Attachment 4 - PLN18/0442 - 291-295 Swan Street Richmond - External Urban Design comments on Decision Plans

291-295 Swan Street, Richmond

Addendum to Urban Design Referral – YARRA CITY COUNCIL

Date	10 July 2020
Council Reference	PLN18/0442
To	Lara Fiscalini, Principal Planner
From	kinetica (formerly David Lock Associates)

Revised overall massing concept

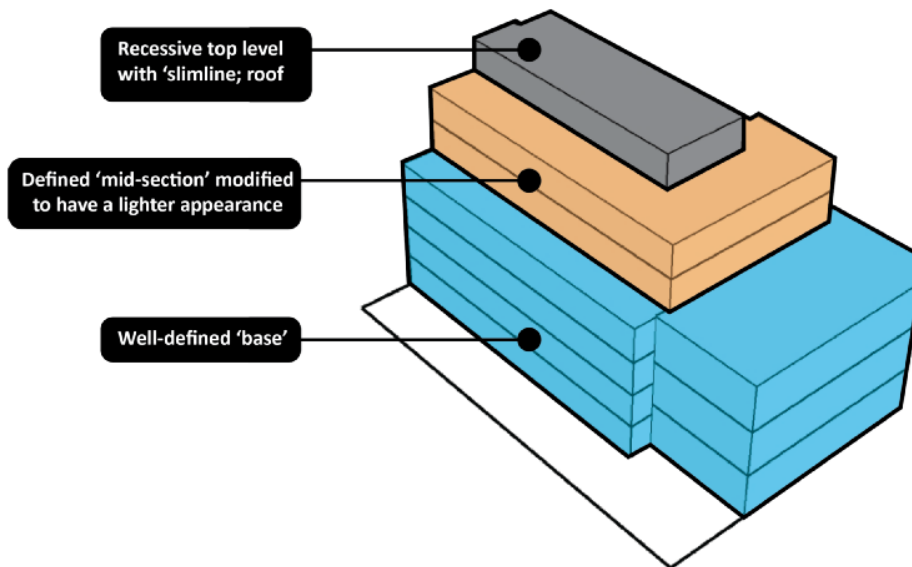
- To simplify the massing, the northern setback of the Fourth Floor should be increased to 8.77m to match the Fifth Floor;
- To ensure the 6th floor reads as a recessive cap and to comply with the requirements of the DDO, the northern setback of the Rooftop Terrace should be increased further; and
- To improve the composition of the building, the materiality of the Fourth and Fifth Floors should be revised to have a lighter appearance. This treatment should also be applied to the lift core, helping it to blend with the building, rather than

These changes will result in a clearer massing composition comprising of a strong 'base', well-defined 2-storey mid-section and, with a recessive Roof Top level. This will also ensure that the upper levels are seen as subservient to the heritage building. The proposed revised materiality will also ensure the upper levels are more subservient to the heritage building, particularly the lift core, which will now blend into the building.

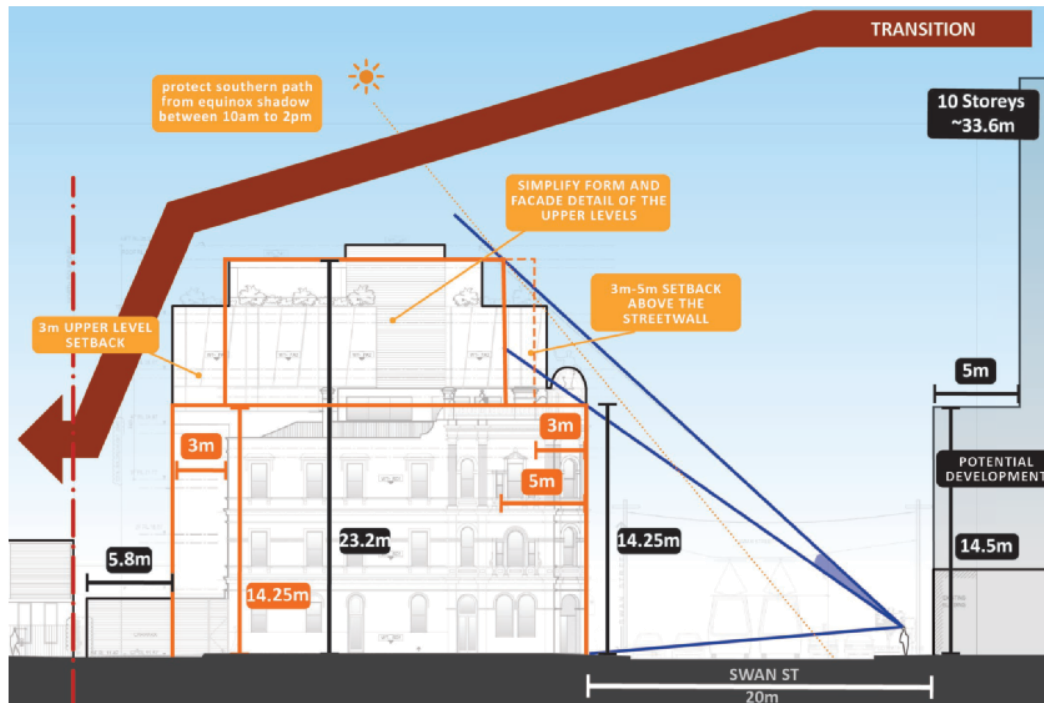
The proposal materials palette above the street wall utilises glazing angular solid banding and glazing at the 5th and 6th storey and a different materials to the 7th storey. This treatment is unnecessarily complicated and appears to draw attention to the upper form and compete with the visual richness of heritage facade and simple facade windows and materials detail in the 4 storey base form.

The material and finished detail of the upper form should be revisited and simplified to create a visually cohesive top form while still maintaining a distinction between the base and the upper form as to appear recessive.

Existing and recommended built form design response (West Elevation-Coppin Street Elevation)

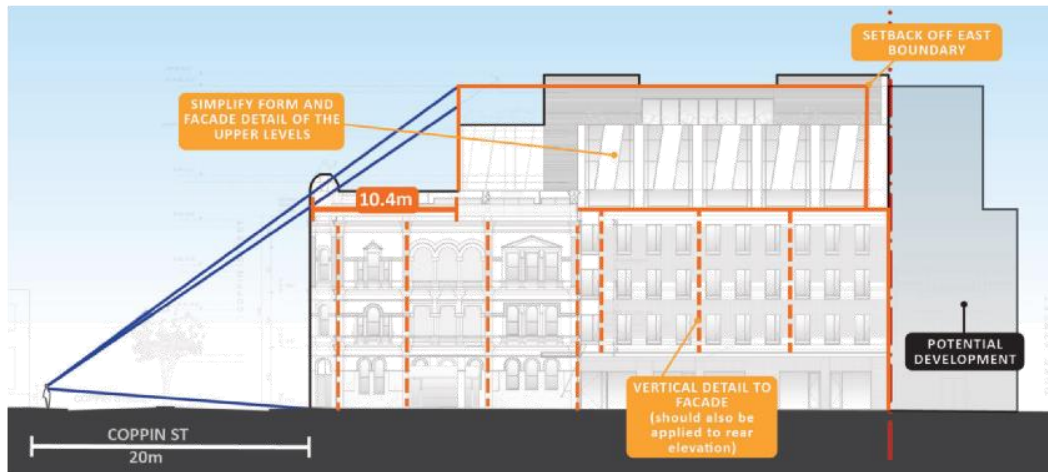
It is recommended that a small setback of the **upper form** (above the 4 storey base) from the eastern boundary be established. This upper form setback will provide an opportunity for windows to be inserted along the eastern upper form elevation and for the front elevation detailing to wrap around to the east elevation so that the building has a better presentation in the round, until the site to the east redevelops. If necessary, the lift and stair core areas could remain on the eastern boundary for the site at 301 Swan Street to mirror.

Existing and recommended built form design response (South elevation- Swan Street Elevation)

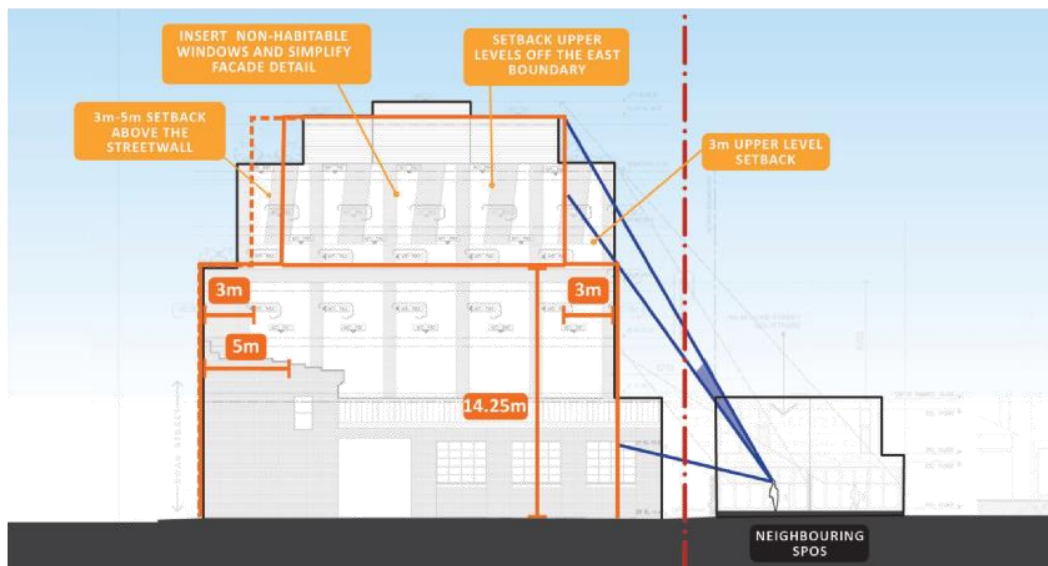
At a height of 14.25m, the Swan Street **street wall** is an appropriate response. By continuing the existing street wall height, albeit with 4 storeys rather than 3 storeys, this creates a clear and continuous street wall to Swan Street. It also beneficially sets up the opportunity for the site to the east at 301 Swan Street to this this street wall condition.

Figure 1 Heritage Overlay Map showing the location of the Former Central Club Hotel. There are no abutting places in the Heritage Overlay but there is the nearby Former Swan Street Drill Hall (HO 440) in Swan Street.

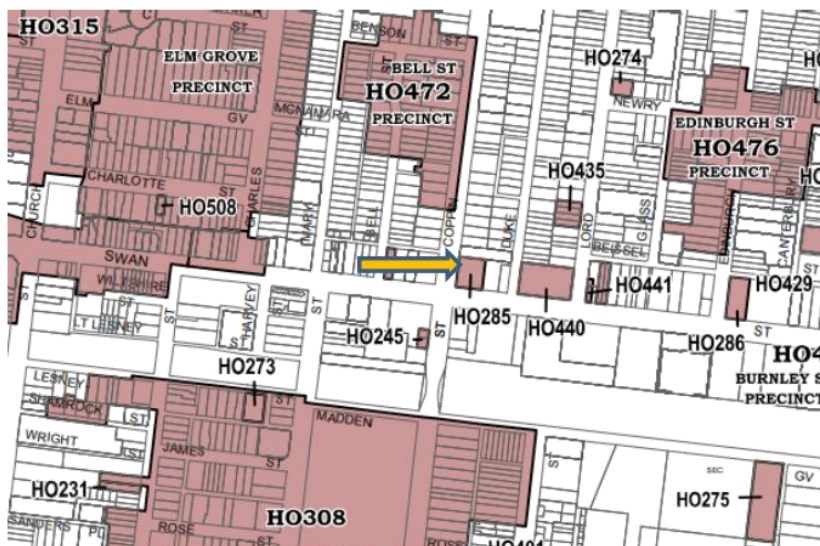
The eastern boundary of the heritage curtilage aligns with the rear boundaries of sites to the north which is further to the east than the east wall of the hotel building. This needs clarification.

If not done already, clarify exactly where the eastern boundary of the heritage curtilage is i.e. the east wall of the hotel or further east as indicated on the Heritage Overlay map.

Figure 1 Heritage Overlay Map showing the location of the Former Central Club Hotel. There are no abutting places in the Heritage Overlay but there is the nearby Former Swan Street Drill Hall (HO 440) in Swan Street.

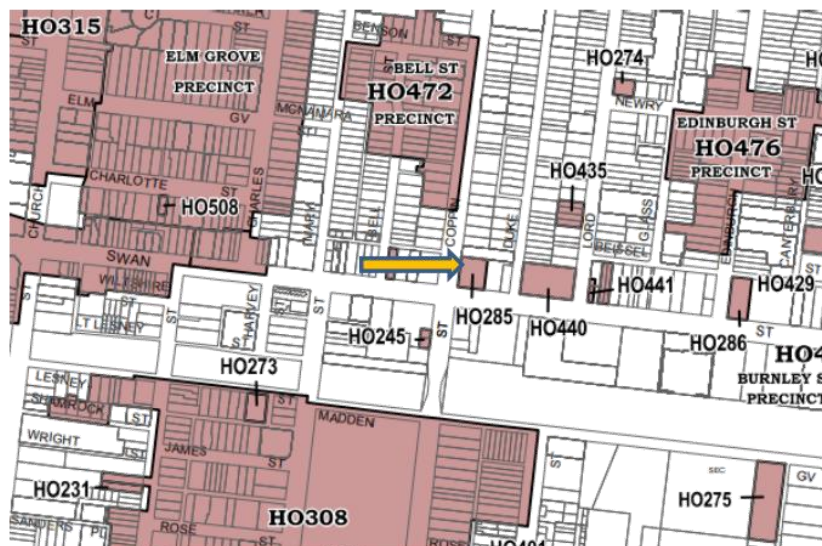
The eastern boundary of the heritage curtilage aligns with the rear boundaries of sites to the north which is further to the east than the east wall of the hotel building. This needs clarification.

Clarify exactly where the eastern boundary of the heritage curtilage is i.e. the east wall of the hotel or further east as indicated on the Heritage Overlay map.
